Subject: College Park Elementary School HVAC Replacement
San Mateo - Foster City School District
Aedis Project No. 2021005.01
DSA Application #01-119530

ADDENDUM NO. 1

College Park Elementary School HVAC Replacement
San Mateo – Foster City School District
Aedis Project No. 2021005.01

1 NEW SITE PLAN
SCALE: 1/32" = 1'-0"

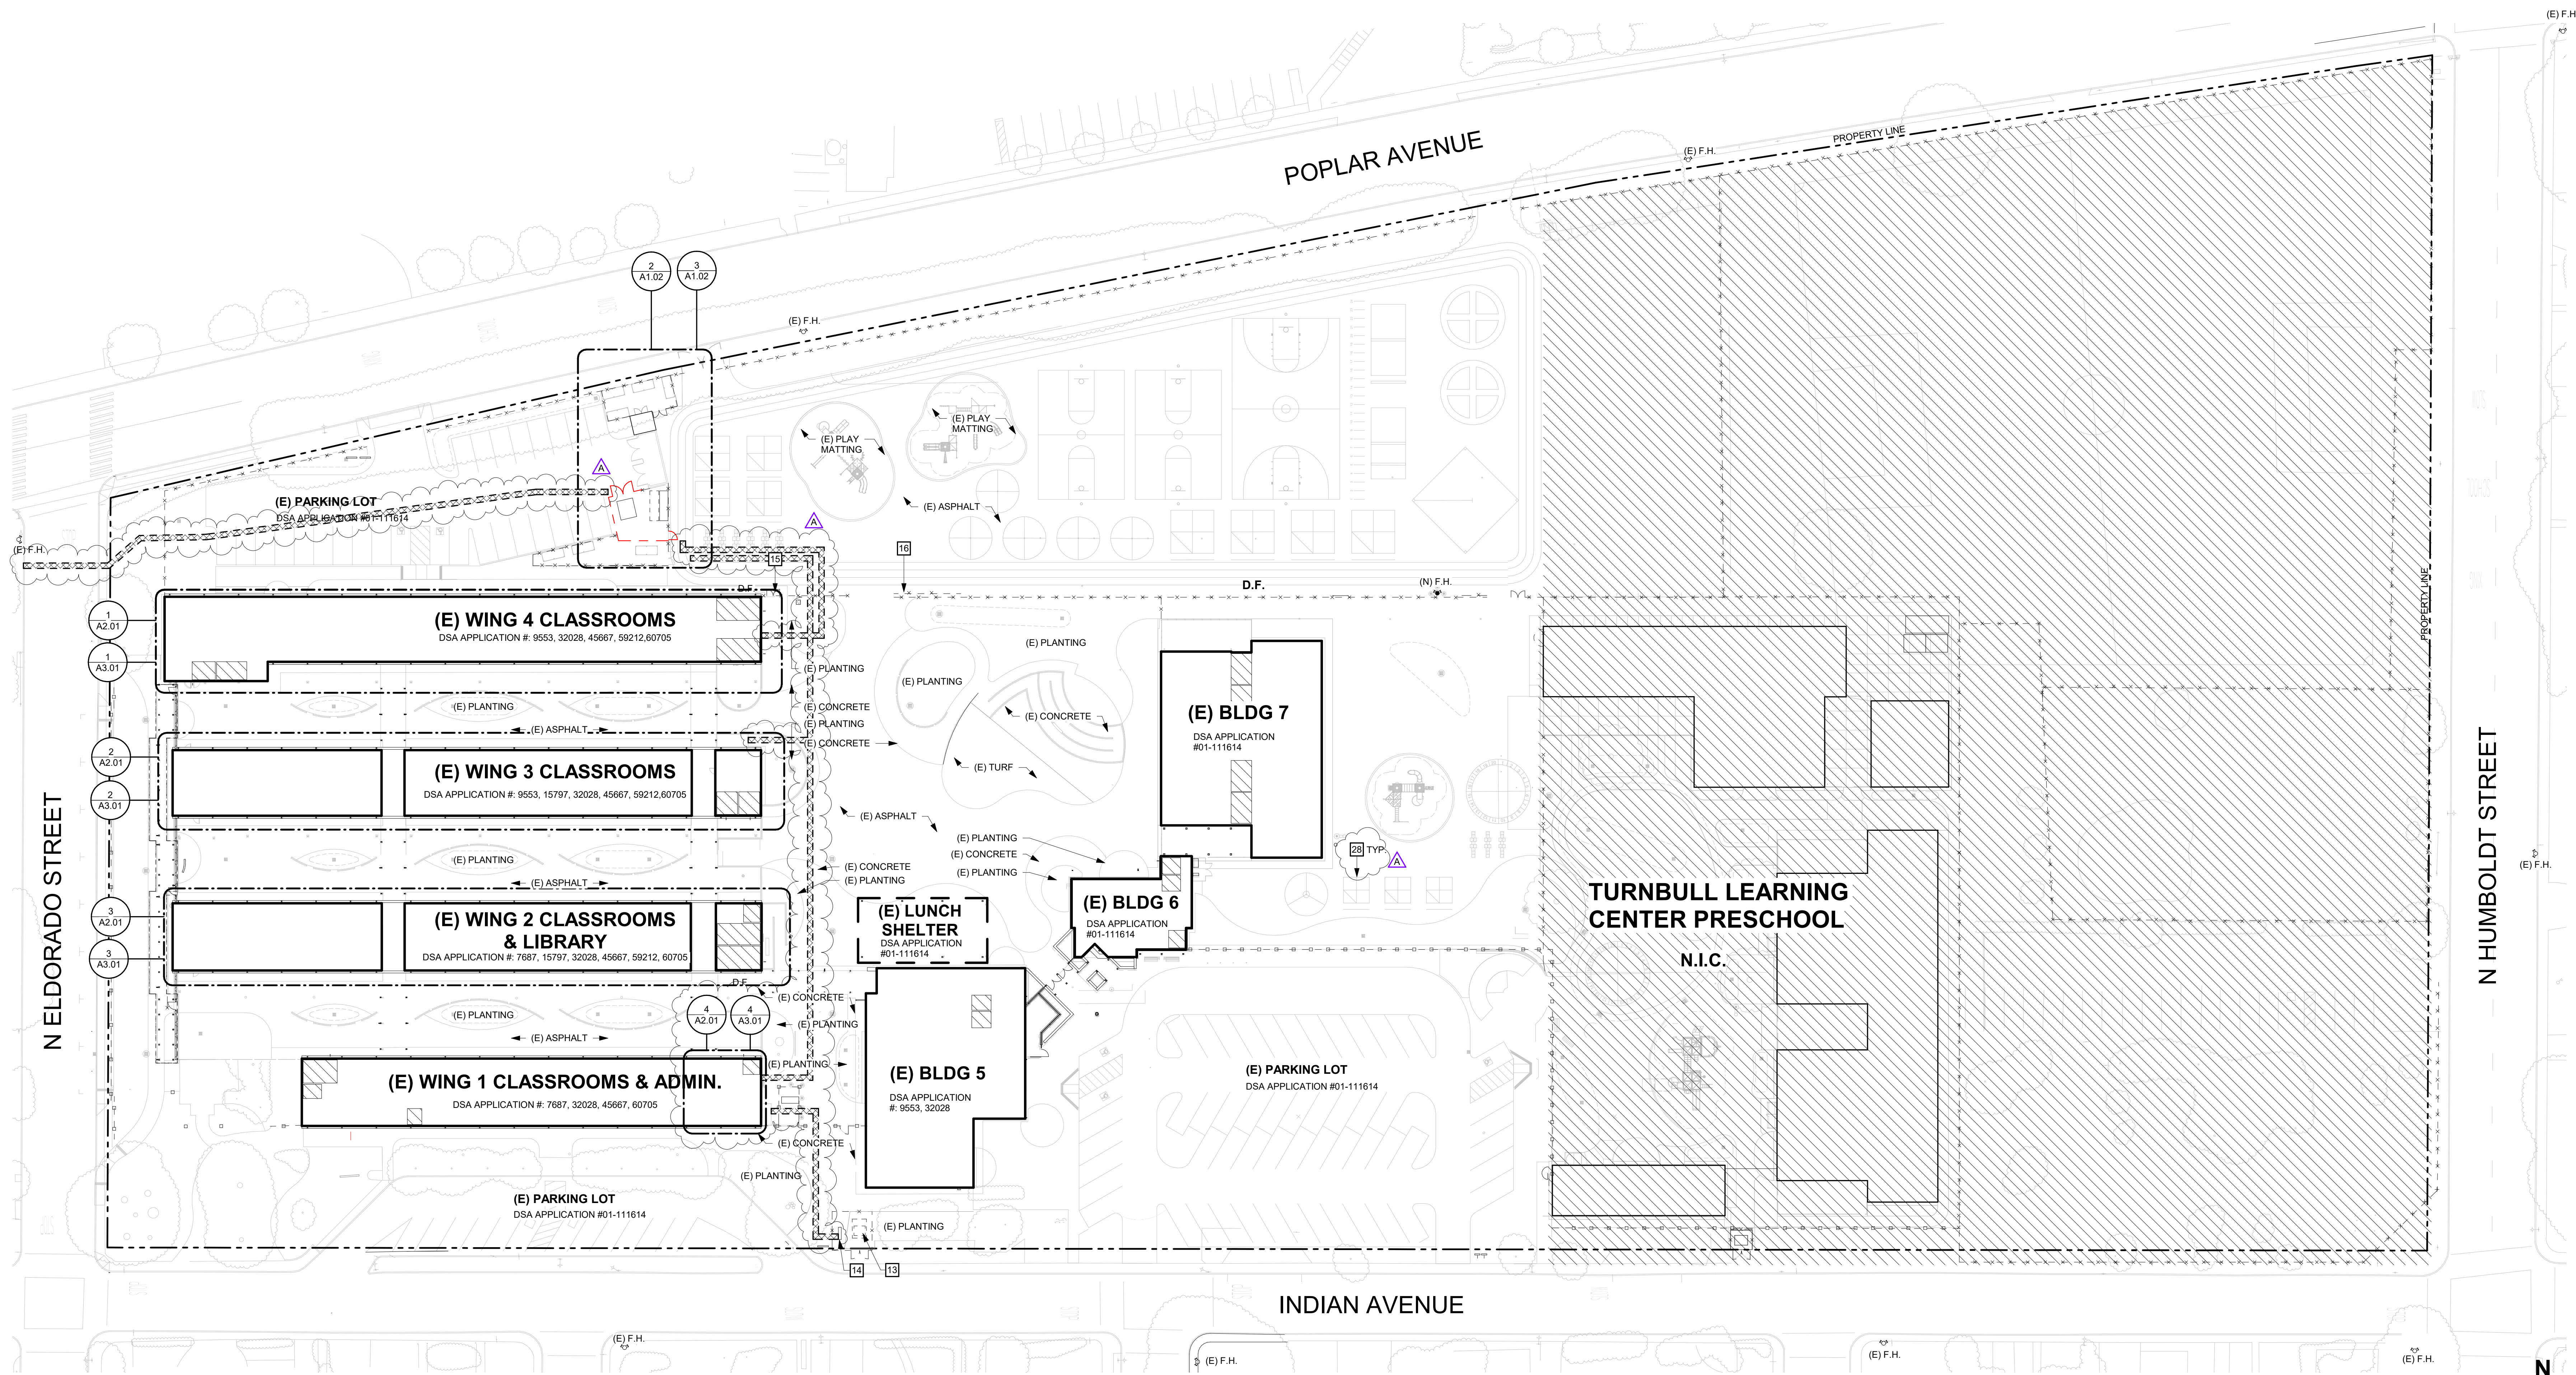
Add: Trench area to New Site Plan 1/A1.02 & Graphic Key per AD1-A1.02
Revise: General Notes #G as shown per AD1-A1.02
Add: Keynote #28 to New Site Plan 1/A1.02 per AD1-A1.02
Add: Enlarged plan call outs to 4/A2.01 & 4/A3.01 in New Site Plan 1/A1.02 per AD1-A1.02

DATE 11/24/2021
JOB # 2021005.01
SHEET # AD1-
A2.01

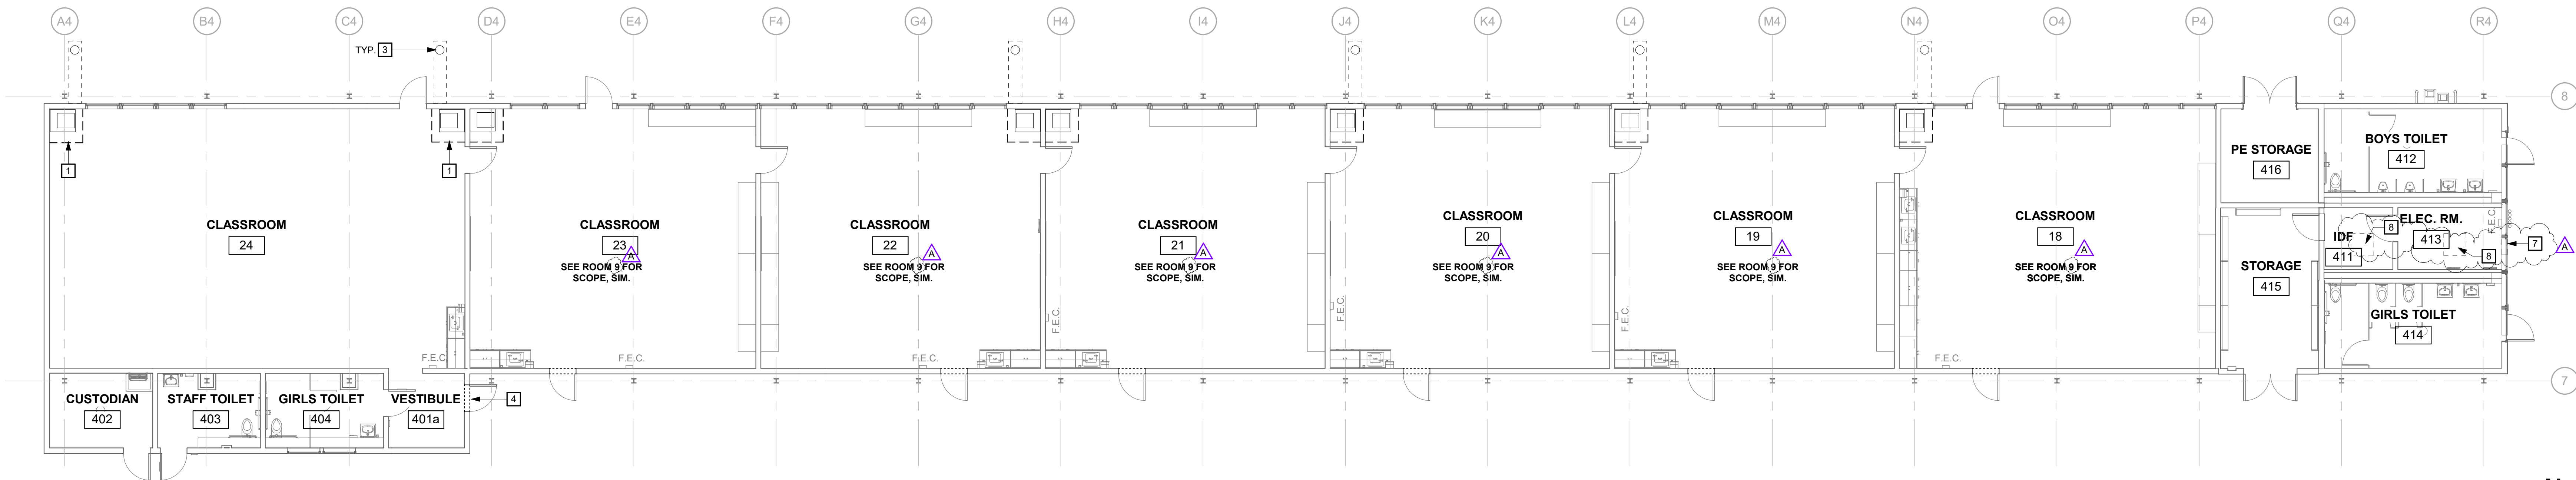
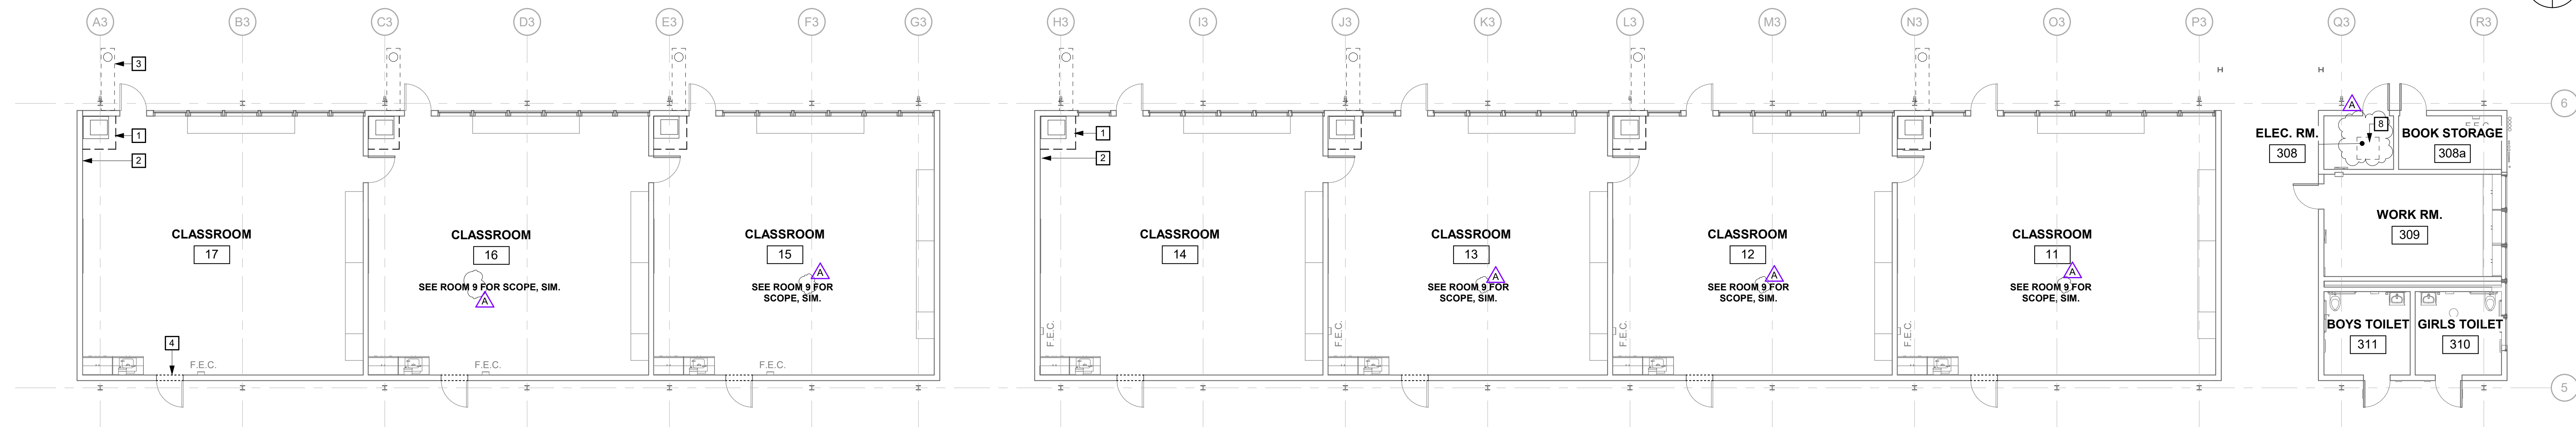
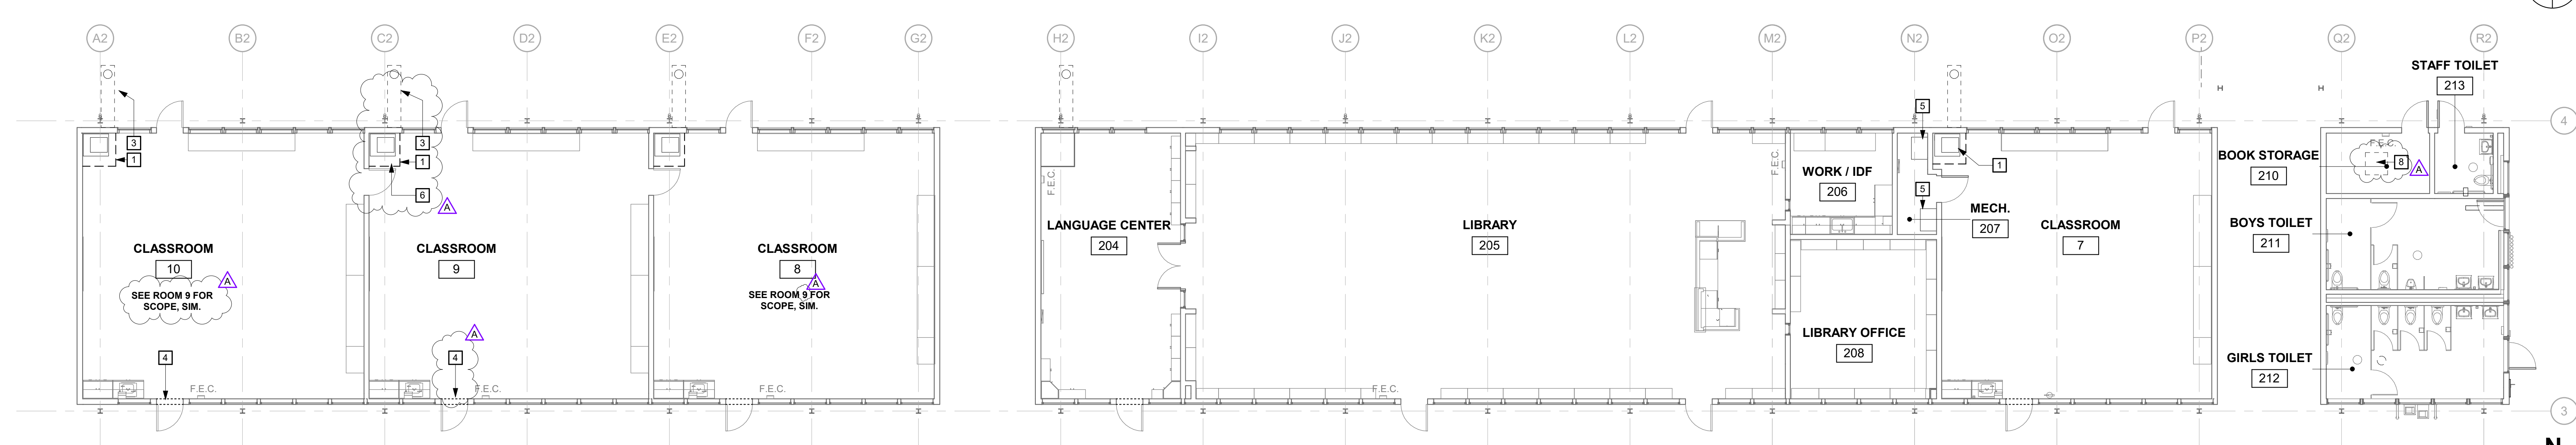
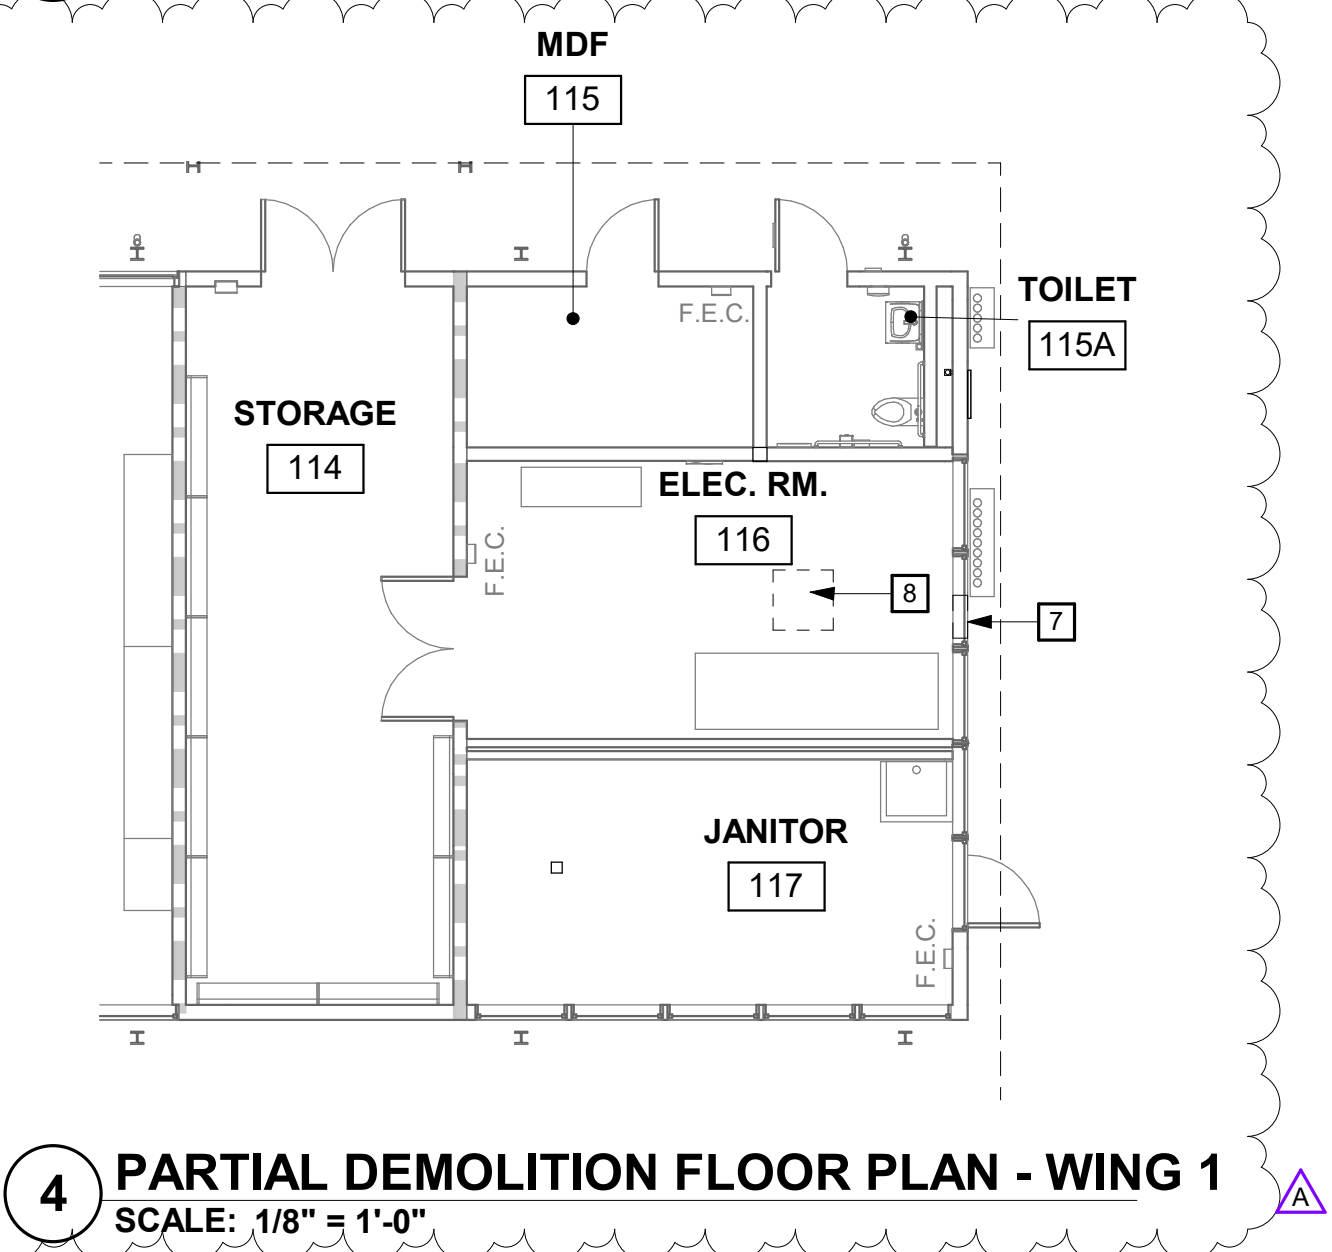
Add: General Sheet Note #J per AD1-A2.01
Add: Door stop keynote #6 to Demolition Floor Plans 1/A2.01, 2/A2.01 and 3/A2.01 per AD1-A2.01
Add: Wall prep for louver keynote #7 to Demolition Floor Plan 1/A2.01 per AD1-A2.01
Add: Partial ceiling demolition keynote #8 to Demolition Floor Plans 1/A2.01, 2/A2.01, and 3/A2.01 per AD1-A2.01
Revise: Reference room 9 for similar scope where occurs in Demolition Floor Plans 1/A2.01, 2/A2.01, and 3/A2.01 per AD1-A2.01
Revise: Demolition Floor Plan Keynote #4 per AD1-A2.01
Add: View 4/A2.01 Partial Demolition Floor Plan – Wing 1 per AD1-A2.01
Revise: Keynotes at rooms 9 and 10 in Demolition Floor Plan 3/A2.01 per AD1-A2.01
